**MITSUBISHI HEAVY INDUSTRIES, LTD.**  
16-5, KONAN 2-CHOME, MINATO-KU  
TOKYO, JAPAN

**Subject:** MHI's Responses to US-APWR DCD RAI No. 625-4924 (SRP 03.07.02)

Response to Request for Additional Information No. 625-4924,  
Revision 0

**RAI NO.:** NO. 625-4924 REVISION 0  
**SRP SECTION:** 03.07.02 – Seismic System Analysis  
**APPLICATION SECTION:** 3.7.2  
**DATE OF RAI ISSUE:** 8/30/10

Figure ANSYS Detailed Model of CIS

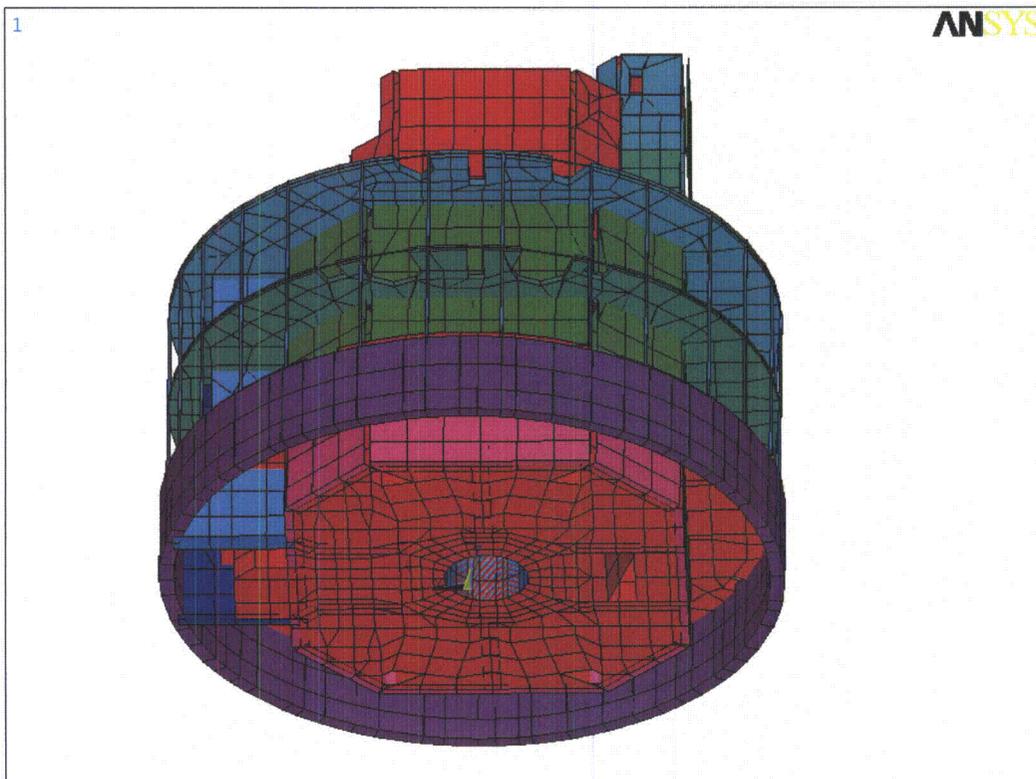
This request for additional information (RAI) is necessary for the staff to determine if the application meets the requirements of 10 CFR Part 50, Appendix A, General Design Criteria 2; 10 CFR Part 50 Appendix S; and 10 CFR Part 100; as well as the guidance in NUREG-0800, 'Standard Review Plan for the Review of Safety Analysis for Nuclear Power Plants,' Chapter 3.7.2, 'Seismic Design Parameters.

- a) The lumped mass stick model used for soil-structure interaction (SSI) analysis was reviewed to confirm the model has sufficient accuracy of stiffness to properly capture the dynamic response of the structure of interest and if acceptable modeling procedures are employed per above RAI 625-4924 Rev. 0, Question 03.07.02-11 response a.
- b) A comparison of the shapes of lateral deformations presented in Figure 5.3.5.1- 1 to 4 shows that they are consistent in shape in almost all locations. Discrepancies can be noticed in the lateral displacements of IC00-IC61 branch at elevations below elevation 25 ft corresponding to the elevation of the lumped mass node IC02. The detailed FE model of the containment internal structure (CIS) uses two types of elements to represent the stiffness of the bottom 25

fit of the structure, shell elements in purple representing the steel/structure walls at the CIS periphery and solid elements in red representing the CIS central portion. The CIS lumped-mass stick model uses only one stick element between two floor elevations to represent the overall stiffness of the structure. Figures 5.3.5.1-1 through 5.3.5.1-4 of MUAP 10001 Rev. 1 show a variation in the results obtained from the analysis of the detailed FE model for the displacements of the periphery of the model that are due to variation of the local stiffness of the CIS part of the structure modeled with shell elements. The discrepancies in the deformation results can be explained by the local effects that are not captured by the stick elements of the CIS lumped mass stick model. As discussed in the response of Question 03.07.02-11 part b of this RAI, a 3-D FE SASSI model of the R/B complex structures is under construction that will provide a better representation of the local stiffness distribution of the CIS structure.

Preliminary Revised Figure 5.3.5.2-1 ANSYS Dynamic Model Transfer Functions, X-Direction

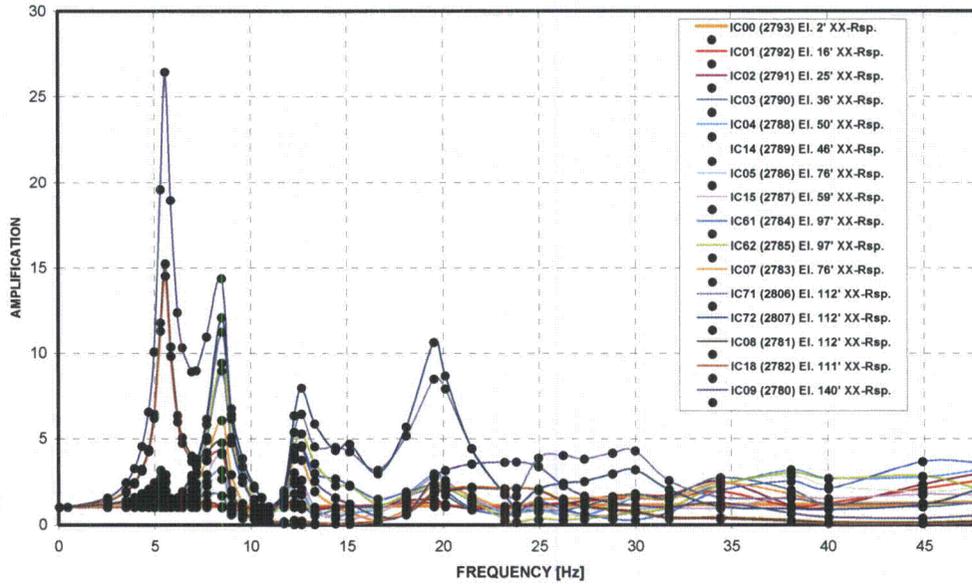
Table 5.3.5.2-1 of MUAP-10001, Rev. 1 shows the modal properties of the detailed distributed mass CIS finite element model in the N-S direction. The first three natural frequencies of the CIS in the N-S direction are shown as 6.2 Hz, 8 Hz, and 11.3 Hz. In Figure 5.3.5.2-1, the first two peaks in the transfer functions occur at approximately 5 Hz and 7.5 Hz. Specifically, the amplifications in the transfer functions at the frequencies in Table 5.3.5.2-1 are significantly lower than the peak amplifications.

Explain how MHI propose to resolve such discrepancies and account for the fact that the natural frequencies in the N-S direction as calculated from the detailed distributed mass model fall in "valleys" and not on the 'peaks' of the transfer functions from the lumped mass stick model. The applicant should resolve the differences in responses of the lumped mass and distributed mass models of the CIS and develop a lumped mass stick model that adequately captures and predicts distributed mass model seismic responses in both frequency and in magnitude.

b) Section 5.3.5.2 of MUAP 10001 Rev. 1 presented the results of modal analysis of the detailed finite element (FE) model of the containment internal structure (CIS) with full stiffness (uncracked concrete) conditions that was decoupled from the reactor coolant loop (RCL) model. The transfer function results presented in Figures 5.3.5.2-1 to 5.3.5.2-3 of MUAP 10001 Rev. 1 were obtained from the hard rock SSI analysis of the lumped-mass stick model that is coupled with the RCL model and has reduced stiffness (cracked concrete) properties. The first figure provided in this response presents the preliminary results of modal analysis of the coupled detailed FE model with full stiffness (uncracked) properties in terms of the mode cumulative mass fraction in N-S direction and modal frequency. The steep increases in the graph of the cumulative mass fraction indicate significant modes of vibration in N-S direction. The table below summarizes the frequencies of the first three dominant modes of vibration of the CIS in N-S direction that were obtained from the ANSYS modal analysis of the coupled detailed FE model with full stiffness (uncracked) properties. The second figure provided in this response presents the transfer function results obtained from the hard rock SSI analyses of the coupled CIS lumped-mass stick model with full stiffness (uncracked) properties resting on the surface of a half-space with high (hard rock)stiffness properties.

The comparison of the results for the response of the CIS model in the N-S direction shows that the difference between the frequency of the peak transfer function amplification obtained from the ACS SASSI SSI analyses of the lumped mass stick model and the natural frequency of the first two dominant modes obtained for the ANSYS modal analysis of the detailed FE model is 6%. These results indicate acceptable correlation of the dynamic properties between the two models. As described in the response to Question 03.07.02-11 part b of this RAI, the 3-D dynamic FE SASSI model of the R/B complex structures that is under construction will be used to further investigate the effect of the higher local modal responses of the CIS on the SSI results.

There is no impact on the DCD. The next revision of report TR MUAP-10001 will incorporate a revised figure and table in Section 5.3.5.2 for the CIS in the N-S direction as discussed above. Further validation using a SASSI FE will be documented in a future revision of TR MUAP-10001.

**Preliminary Revised Figure 5.3.5.2-2 ANSYS Dynamic Model Transfer Functions, Y-Direction**

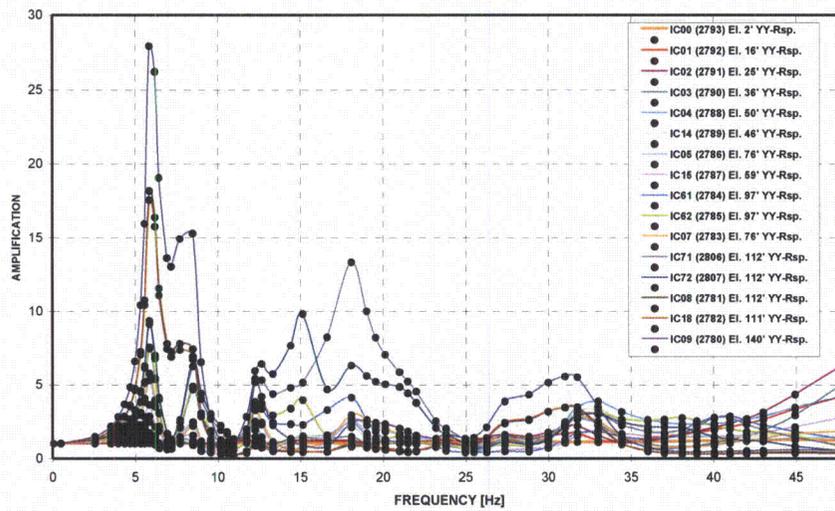
Table 5.3.5.2-2 of MUAP-10001, Rev. 1 shows the modal properties of the detailed distributed mass CIS finite element model in the E-W direction. The first three natural frequencies of the CIS in the E-W direction are shown as 6.4 Hz, 7.6 Hz, and 11.7 Hz. In Figure 5.3.5.2-2, the first two peaks in the transfer functions occur at approximately 5.25 Hz and 7.5 Hz. Specifically, the amplification at 6.4 Hz in the transfer functions is significantly lower than the peak amplification at 5.25 Hz. Also, it appears that the third natural frequency at 11.7 Hz does not appear at all in the transfer functions shown in Figure 5.3.5.3-2.

Explain how MHI propose to resolve such discrepancies and account for the discrepancies in the dynamic response of the lumped mass stick model and the distributed mass model of the CIS in the E-W direction. The applicant should resolve the differences in responses of the lumped mass and distributed mass models of the CIS and develop a lumped mass stick model that adequately captures and predicts distributed mass model seismic responses in both frequency and in magnitude.

- b) As noted in the response to Question 03.07.02-15 part b of this RAI, the detailed finite element (FE) model of the containment internal structure (CIS) considered full (uncracked concrete) stiffness properties while the lumped mass model used for the SSI analyses incorporated reduced (cracked concrete) stiffness properties. The dominant frequencies reported in the MUAP-10001 Rev 0 and 1 technical reports were obtained from the modal analysis of the detailed FE model that was decoupled from the reactor coolant loop (RCL) model. The first figure provided in this response presents the preliminary results of modal analysis of coupled detailed FE model with full stiffness (uncracked) properties in terms of the mode cumulative mass fraction in E-W direction and modal frequency. The steep increases of cumulative mass fraction indicate significant modes of vibration in E-W direction. The table below presents the frequencies of the first three dominant modes of vibration of the CIS in E-W direction that were obtained from the ANSYS modal analysis of the coupled detailed FE model with full stiffness (uncracked) properties. The figure below presents the results of the SSI analysis for the transfer functions for the response in E-W direction that were obtained from the hard rock SSI analyses of the coupled CIS lumped-mass stick model with full stiffness (uncracked) properties.

The comparison of the results for the response of the CIS model in the E-W direction shows that the difference between the frequency of the peak transfer function amplification obtained from of the ACS SASSI SSI analyses of the lumped mass stick model and the natural frequency of the first dominant mode obtained for the ANSYS modal analysis of the detailed FE model is 4%. These results indicate acceptable correlation of the dynamic properties between the two models. As described in the response to Question 03.07.02-11 part b of this RAI, the 3-D dynamic FE SASSI model of the R/B complex structures that is under construction will be used to further investigate the effect on the SSI results of the higher modal responses of the CIS.

There is no impact on the DCD. The next revision of report TR MUAP-10001 will incorporate a revised figure and table in Section 5.3.5.2 for the CIS for the E-W direction as discussed above. Further validation using a SASSI FE will be documented in a future revision of TR MUAP-10001.

**Preliminary Revised Figure 5.3.5.2-3 ANSYS Dynamic Model Transfer Functions, Z-Direction**

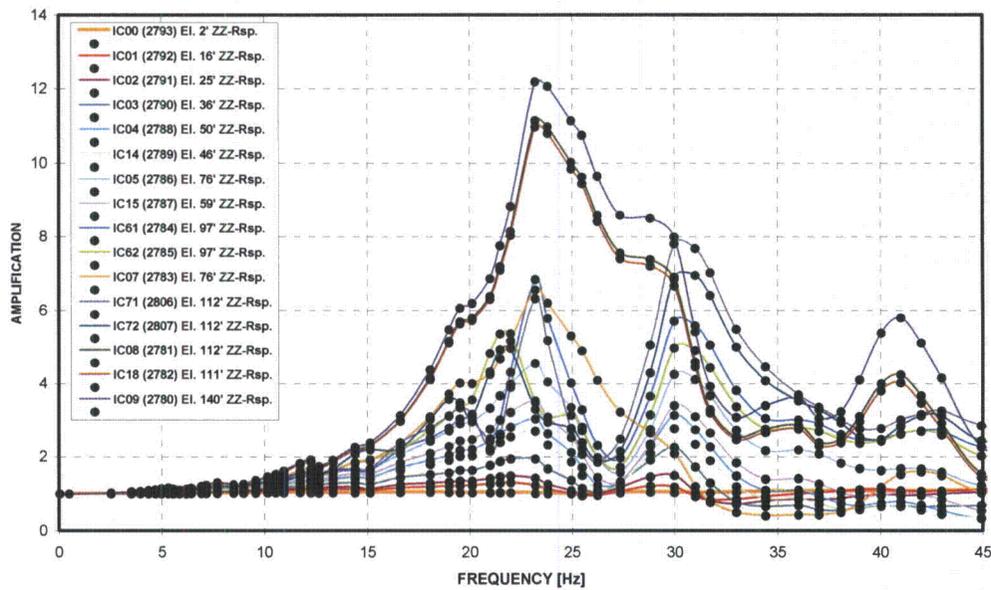
Table 5.3.5.2-3 of MUAP-10001, Rev. 1 shows the modal properties of the detailed distributed mass CIS finite element model in the vertical direction. The first three natural frequencies of the CIS in the vertical direction are shown as 13.3 Hz, 17.2 Hz, and 19.7 Hz. In Figure 5.3.5.2-3, there is no indication that the first vertical frequency at 13.3 Hz is captured in the transfer functions.

Explain how MHI propose to resolve such discrepancies and account for the discrepancies in the dynamic response of the lumped mass stick model and the distributed mass model of the CIS in the vertical direction. The applicant should resolve the differences in responses of the vertical lumped mass and distributed mass models of the CIS and develop a lumped mass stick model that adequately captures and predicts distributed mass model seismic responses in both frequency and in magnitude.

b) As noted in the response to Question 03.07.02-15 part b of this RAI, the detailed finite element (FE) model of the containment internal structure (CIS) considered full (uncracked concrete) stiffness properties while the lumped mass model used for the SSI analyses incorporated reduced (cracked concrete) stiffness properties. The dominant frequencies reported in the MUAP-10001 Rev 0 and 1 technical reports were obtained from the modal analysis of the detailed FE model that was decoupled from the reactor coolant loop (RCL) model. The first figure provided in this response presents the preliminary results of modal analysis of coupled detailed FE model with full stiffness (uncracked) properties in terms of the mode cumulative mass fraction in vertical direction and modal frequency. The steep increases of cumulative mass fraction indicate significant modes of vibration in vertical direction. The second figure provided in this response presents the mode shape of the first mode with significant mass participation in the vertical direction which is at a frequency of 13.5 Hz. The mode shape shows that the first mode in vertical direction represents the vertical vibration of the steam generators and their response. The mode shapes of the higher modes of vibrations indicated that the vertical response of the structure is characterized by multiple modes in the frequency range of 17 Hz to 22 Hz. The table below presents the preliminary updated frequency values for the dominant modes of vibration of the CIS in the vertical direction that were obtained from the ANSYS modal analysis of the coupled detailed FE model with full stiffness (uncracked) properties. The last figure that is included in this response presents the results of the SSI analysis for the transfer functions for the response in the vertical direction that were obtained from the hard rock SSI analyses of the coupled CIS lumped-mass stick model with full stiffness (uncracked) properties.

The first dominant vertical modal frequency obtained from the modal analysis of the CIS detailed FE model is not evident in the transfer functions generated from the results of the hard rock SSI analysis of the lumped mass stick model because this mode represents the vertical vibrations of the equipment included in the RCL lumped mass stick model that is coupled to the CIS. The vertical response of the CIS itself in the detailed model is characterized by multiple modes with a wider variety of frequencies. On the other hand, the vertical response captured by lumped-mass stick model is concentrated to fewer modes of vibration. As described in the response to Question 03.07.02-11 part b of this RAI, the 3-D dynamic FE SASSI model of the R/B complex structures that is under construction will be used to investigate the effect of the multiple higher frequency vertical modes of vibration of the CIS on the SSI results.

There is no impact on the DCD. The next revision of report TR MUAP-10001 will incorporate a revised figure and table in Section 5.3.5.2 for the CIS vertical direction as discussed above. Further validation using a SASSI FE will be documented in a future revision of TR MUAP-10001.

Revised Figure 5.3.5.3-1 Acceleration Response Spectrum Node IC03, NS Direction

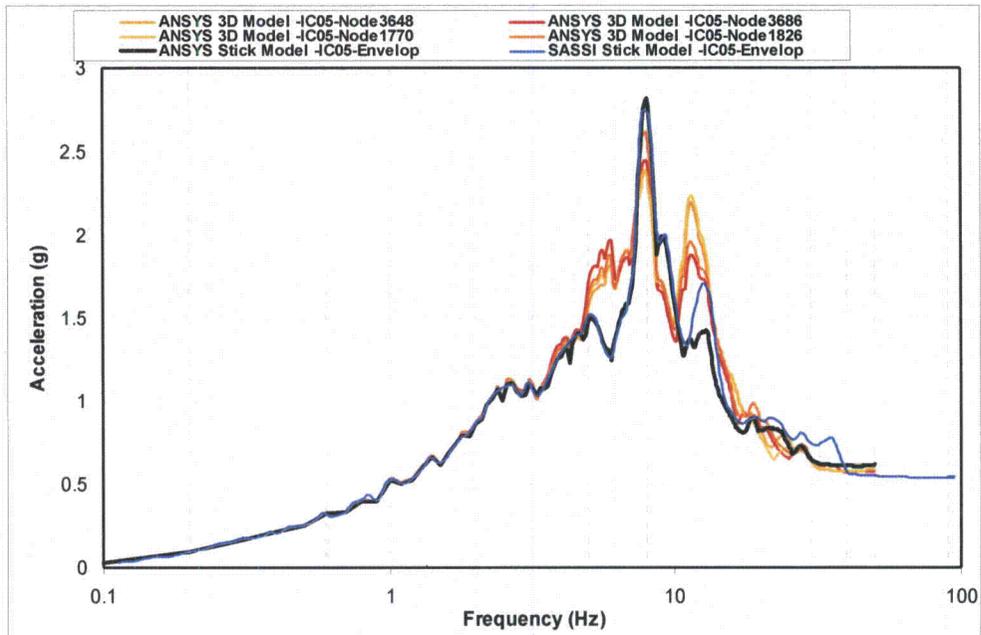
As an example, in Figure 5.3.5.3-3 the peak spectral acceleration at 16 Hz from the distributed mass model is 1.6g, while for the lumped mass stick model the peak acceleration is 0.82g, which is approximately 50% lower than the target. Similar discrepancies hold for other figures in this section. It is also evident from Figure 5.3.5.3- 2 that the distributed mass model responds to frequencies that are not predicted by the lumped mass model.

Provide the acceptance criteria used to support the conclusion that the stick models are adequate and how do the acceptance criteria meet the guidelines of the SRP. The applicant should resolve the differences in response from the lumped mass and distributed mass models of the CIS and propose a lumped mass stick model that adequately captures and predicts distributed mass model seismic responses in both frequency and in magnitude.

- b) The review of the acceleration response spectra (ARS) results presented in the figures of Section 5.3.5.3-1 of MUAP 10001 Rev. 1 revealed that the ARS representing the response of the lumped mass stick model in N-S direction were obtained from the ANSYS modal superposition time history of the lumped-mass stick model with reduced stiffness (cracked) concrete properties. The ARS obtained from the ANSYS time history analysis of finite element model and the hard rock SSI analyses of lumped mass stick model for the CIS considered full stiffness (uncracked concrete) properties of CIS structure. The figures below present comparison of the ARS results obtained from the three types of analyses with models with consistent full stiffness properties. The comparison shows close matching between the ARS results obtained from the ANSYS time history and SSI analysis.

It is acknowledged that the lumped-mass stick model has a limited ability to capture higher frequency local responses at all locations as shown by the comparison of the 5% damping ARS results in Figure 5.3.5.3-3 of MUAP 10001 Rev. 1. As described in the response to Question 03.07.02-11 part b of this RAI, a 3-D FE SASSI model of the R/B complex structures is under construction and will be used for site independent SSI analyses. The results from the SSI analyses of SASSI FE model of the R/B complex will be used to validate that the ISRS generated from the lumped-mass-stick model envelope all of the local vibration responses, including such responses as given in Figure 5.3.5.3-3.

There is no impact on the DCD. The next revision of report TR MUAP-10001 will incorporate revised figures and tables in Section 5.3.5.3 for the CIS resulting from the ANSYS time history analyses of lumped mass stick model with full stiffness (uncracked concrete) properties.

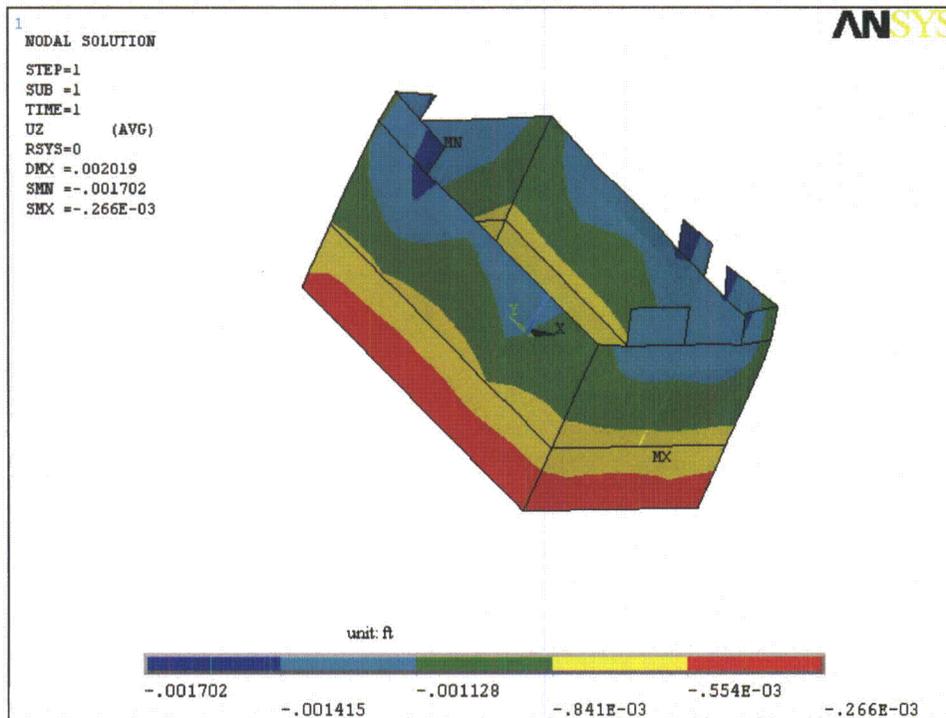
Figure 5.4.2-3 of MUAP-10001, Rev. 1 shows that the vertical displacement at the northwest corner of the PS/B stick model decreases between the 30 foot and 40 foot elevations. Explain the physical interpretation of this result with regards to the safety function of this structure.

The detailed static model and the dynamic structural model discussed in the report are both 3D finite element models. The detailed static model was used for structural design of the Power Source Buildings. It has a more refined mesh and geometry than the dynamic structural model used for SSI analysis. Figure 5.4.2-3 indicates that the vertical displacements at the northwest corner of the PS/B for both models decrease when approaching the top of the wall/roof. The decrease in the displacement is more pronounced in the dynamic model than in the detailed static model because of differences in accuracy introduced by the structural discretization. The decrease in the vertical displacement at the northwest corner indicates a stretching effect from the roof slab corner reaction. As pointed out by Timoshenko when discussing the boundary condition for downward loaded rectangular plate (Timoshenko, Theory of Plates and Shells, Second Edition, Page 86): "... the corners in general have a tendency to rise, and this is prevented by the concentrated reactions at the corners,..." The tendency to rise at four corners of the roof under 1-g static loads imposes a stretching effect on the wall. The stretching stress on the wall decreases at lower elevations because of the stress spreading/distribution, and the effect

of stretching is eventually offset by the increase of the gravity load at some elevation. The figure below shows the vertical displacement contour of dynamic structural model under 1-g static load. The roofs are not shown in the figures. The figure indicates that the vertical displacements at wall corners above a certain elevation are much smaller than the displacement at the central portion of the wall. This verifies the existence of the stretching effects.

It should be noted that the stretching effects as shown by FE discretized model represent upper bound effects. The real effect on the structure is much less than the one shown for the dynamic model case. For the dynamic model case, as shown in Figure 5.4.2-3, the decrease in vertical displacement from el.30 ft to 40 ft is on the order of 0.0004 inch and as such it is considered to be negligible. As far as structural design is concerned, since the detailed static model was used for design, the stretching effect was captured in the design analysis and therefore there is no effect on the safety function of the structure. The comparison of the results obtained from the dynamic analyses of detailed FE model in ANSYS and the dynamic structural model in ANSYS and ACS SASSI show that this discrepancy in modeling local strain and stress distributions have almost no effect on the ability of the dynamic structural model to accurately represent the dynamic behavior of the building.
